Burlington Development Review Board

BURLINGTON DEVELOPMENT REVIEW BOARD Tuesday January 19, 2016, 5:00 PM Contois Auditorium, City Hall, 149 Church Street, Burlington, VT Minutes

ELEVATIONS

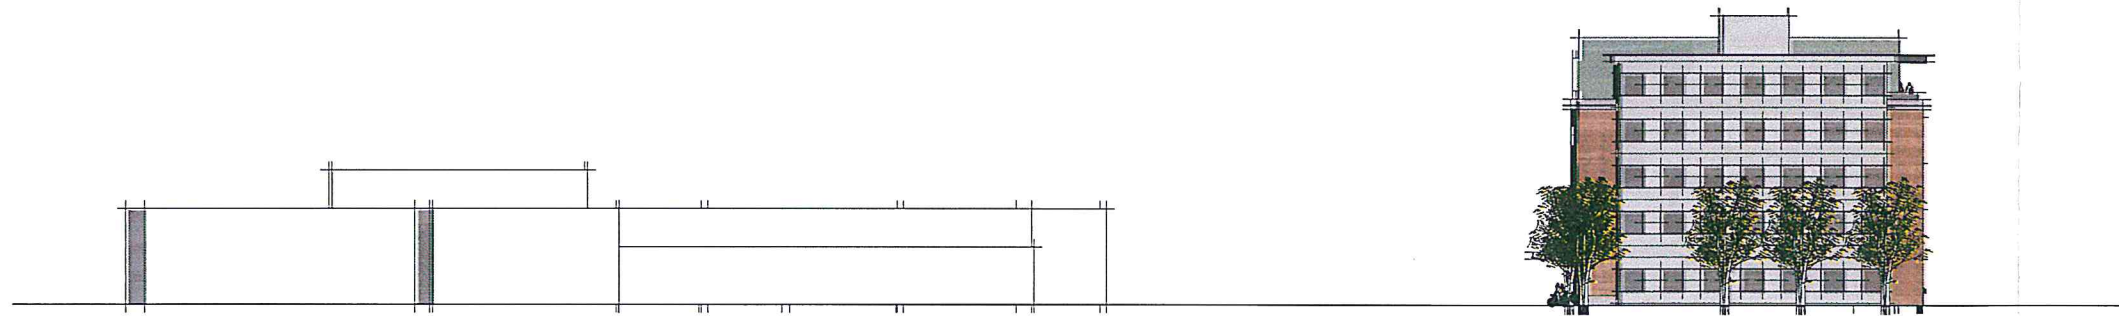
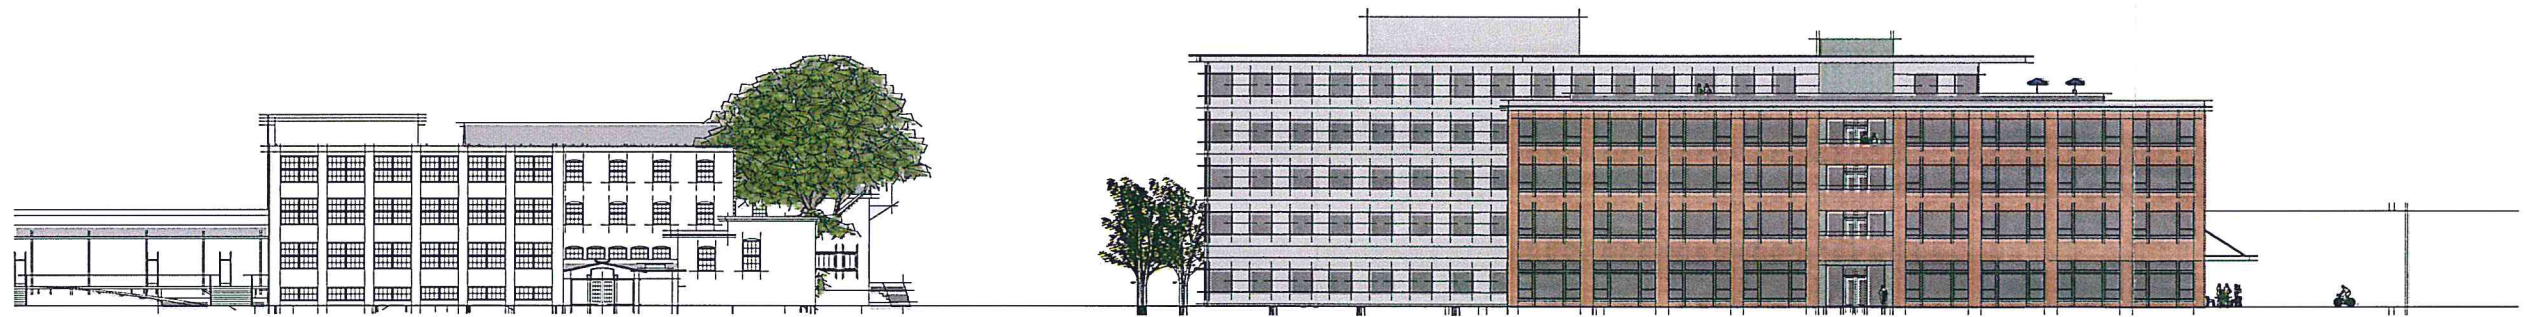
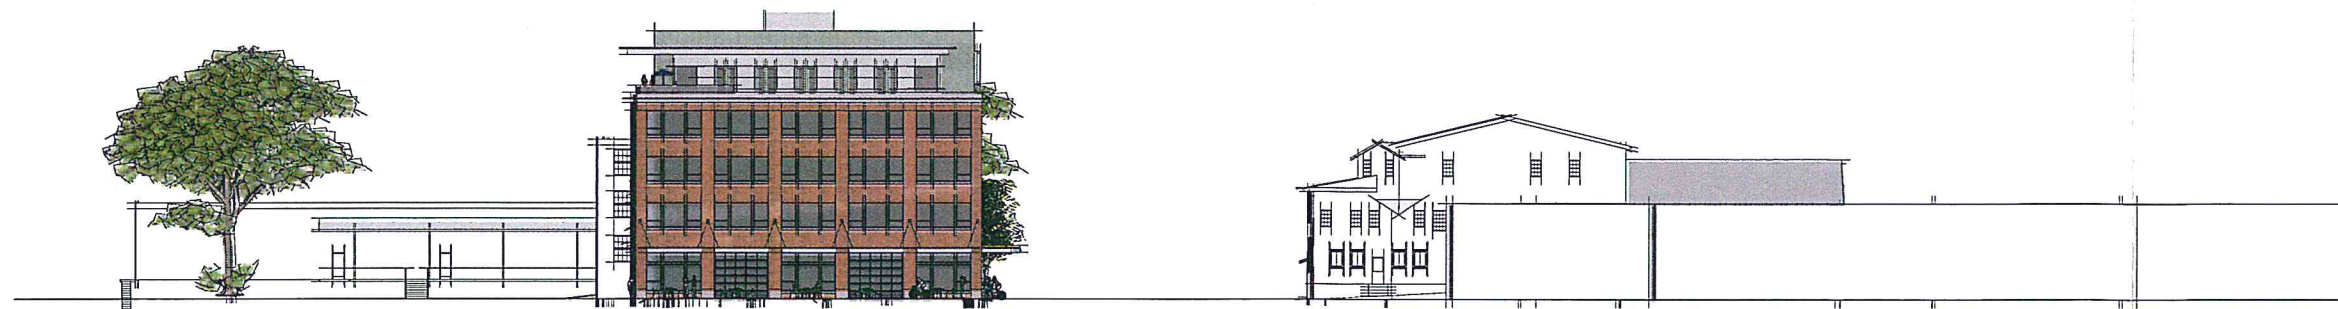
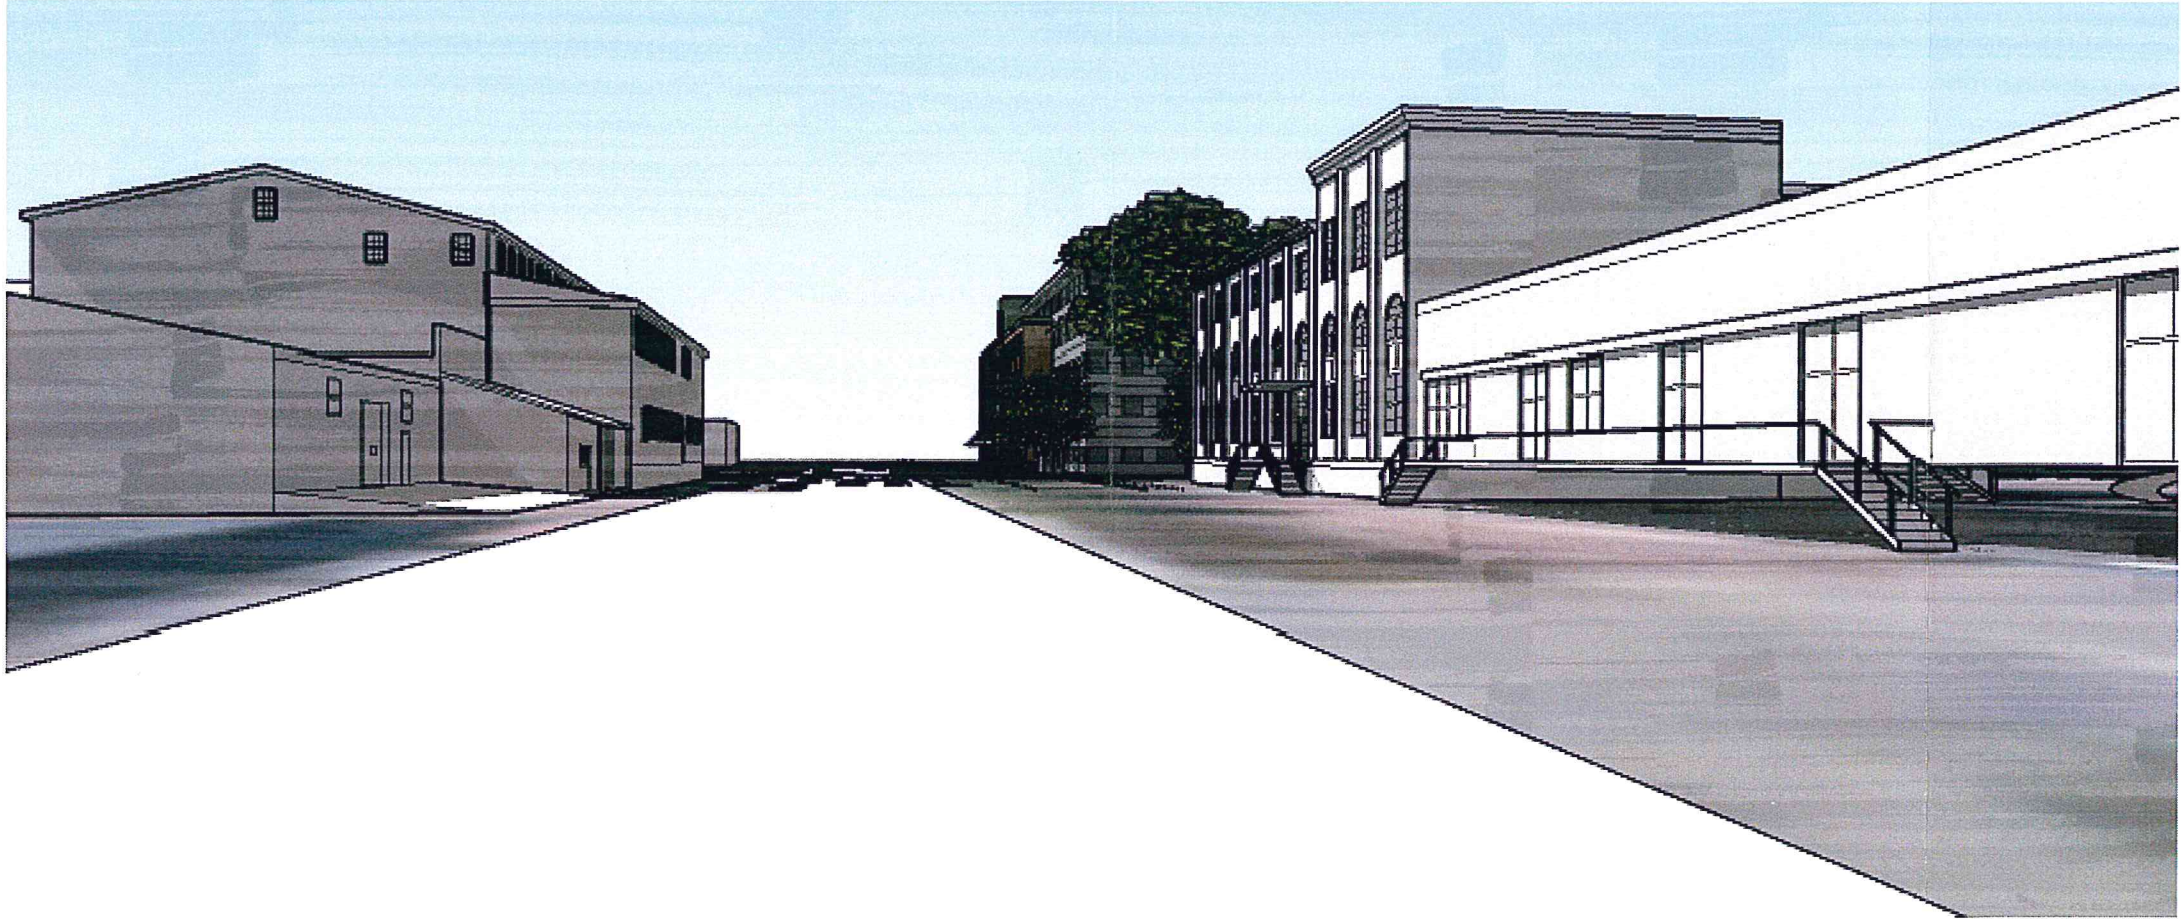
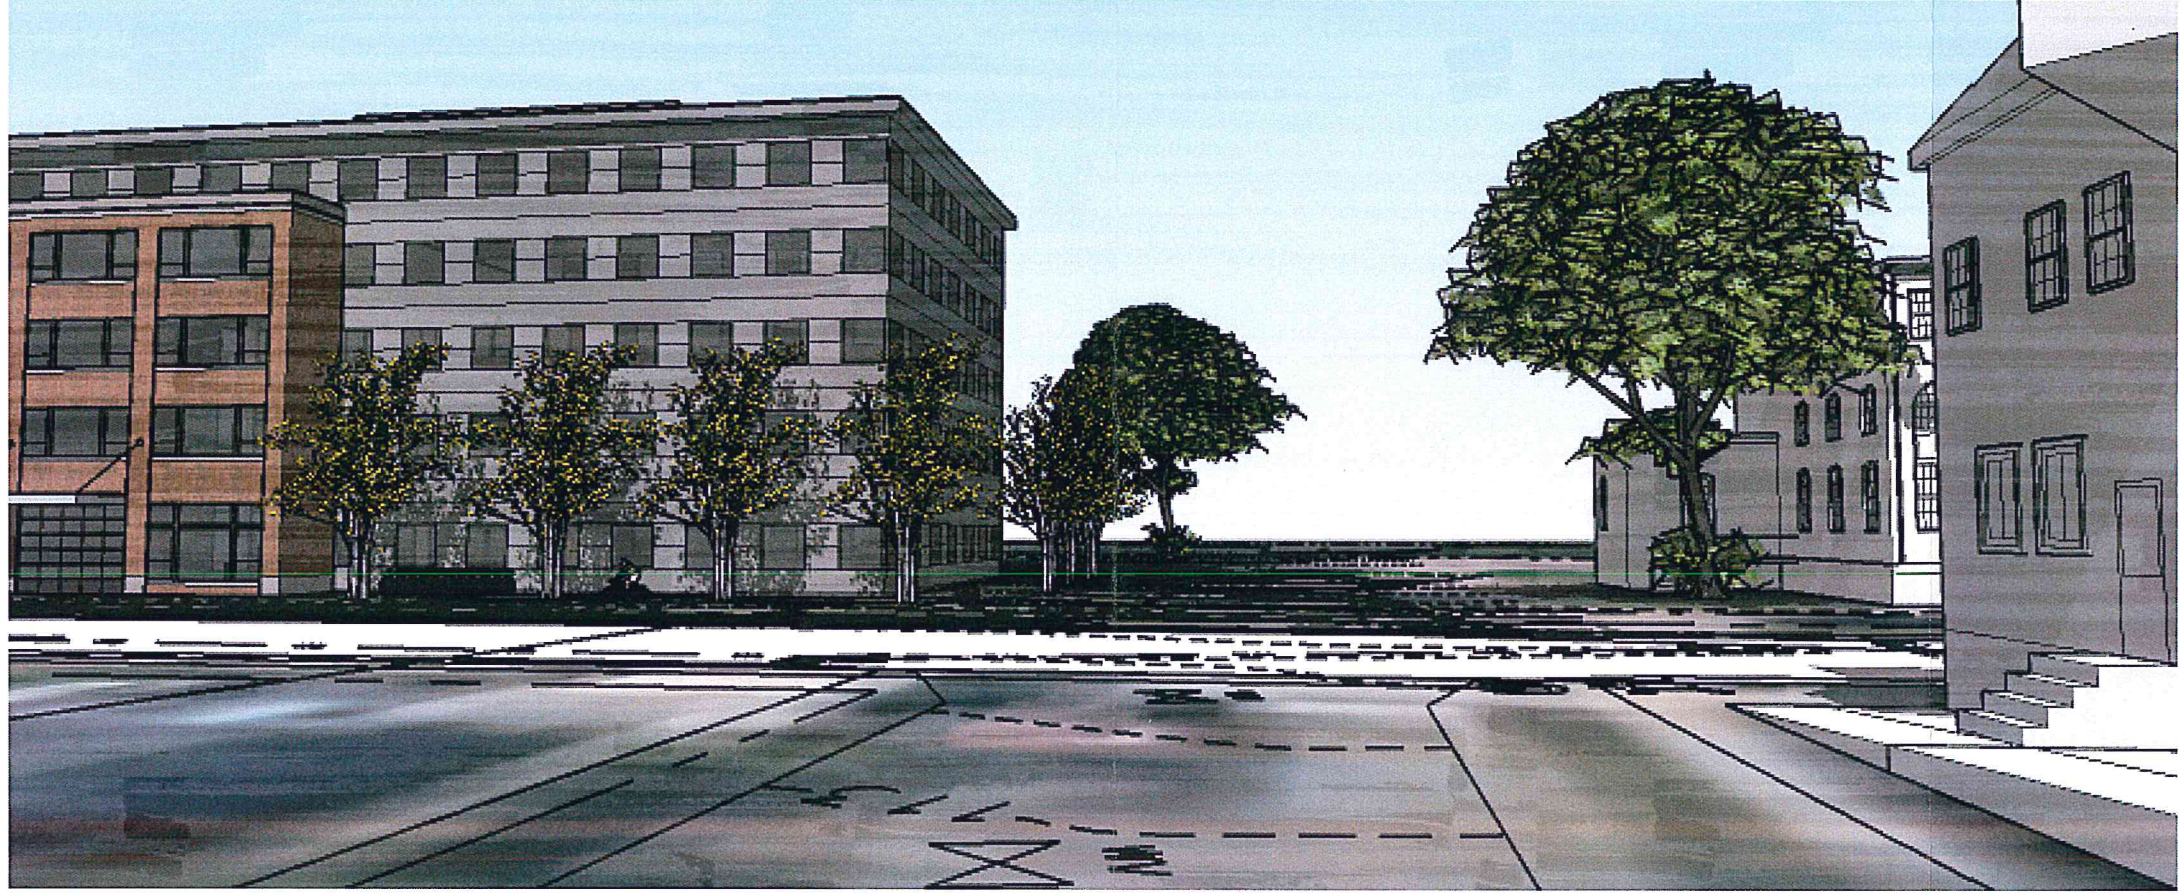
Exact building height is not specified, but at 5 stories, the proposed building presumably exceeds the 45' height limit in the ELM zone and will be one of the taller structures in the South End. Though not articulated in the sketch plans, the applicant is expected to seek the increased height under Sec. 5.4.9, *Brownfield Remediation*. This provision allows waiver of standard dimensional requirements (including height) on brownfield properties. The idea is to allow for flexibility in building design to enable development on sites constrained by contamination. The permit application must specifically address the requirements of Sec. 5.4.9.

The front building section provides the primary interface with the street. As noted above, it has a well-defined front entry linked to the public sidewalk. The street level is differentiated from upper levels with distinct fenestration. The front entry is sheltered by a projecting canopy, and storefront fenestration on either side is likewise accented by overhanging canopies. Ground level windows provide visual access into the building interior. Window mirroring or frosting is not noted and would not be permitted. The building/street interface is further strengthened by the front swath of hardscaping, sitting benches, and artwork.

The sketch plans note no building materials. The permit application must specify all exterior building materials.

While not specifically noted, the sketch plans appear to depict a rooftop mechanical enclosure and elevator penthouse. The permit application must specify these features and their materials and dimensions.

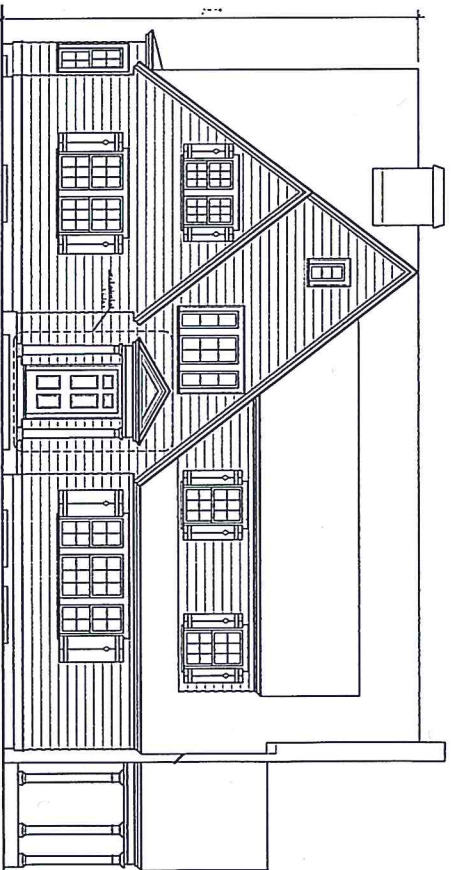
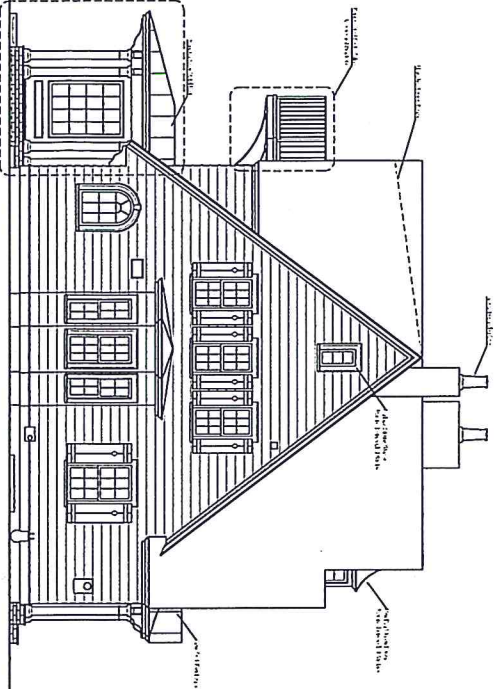
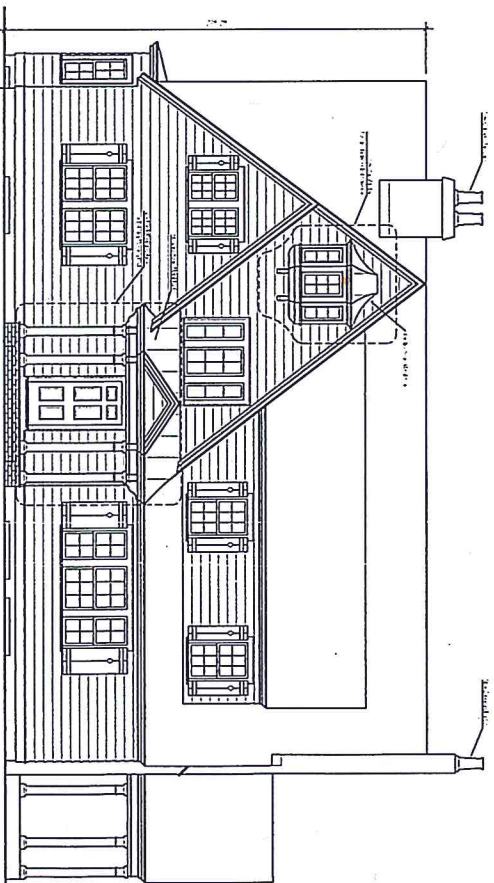
The large third floor bay window is not original to the house, nor was originally proposed in the architectural plans. To add one now is inconsistent with the style and this particular example. **Adverse finding.**

While the massing and height of the structure is not proposed to change from the streetfront, the Design Advisory Board found that the proposed window on the third floor, as presented and projecting from the building plane, was not appropriately scaled to the existing building. **Adverse finding.**

The preceding application proposed replacement of the front door hood with a metal clad shed-roofed canopy, which was approved. The projecting roof on the bay window (under appeal) is proposed to be flat seamed copper. The Design Advisory Board particularly objected to the window protruding from the plane of the primary façade, and specifically did not support that part of the application previously. **Adverse finding.**

Motion by Matt Bushey: Regarding 122 Summit Street, the Board feels the property is eligible for historic listing to the Vermont State Register due to its historic integrity and condition per the standards before us. The Board has no objection to changes proposed for the north, south or east elevations. There is no objection to the proposed alteration of the front entry, as has been revised. The proposed bay window at the 3rd floor of the west elevation is not approved; revision with a larger window in the same plane of the house is acceptable.
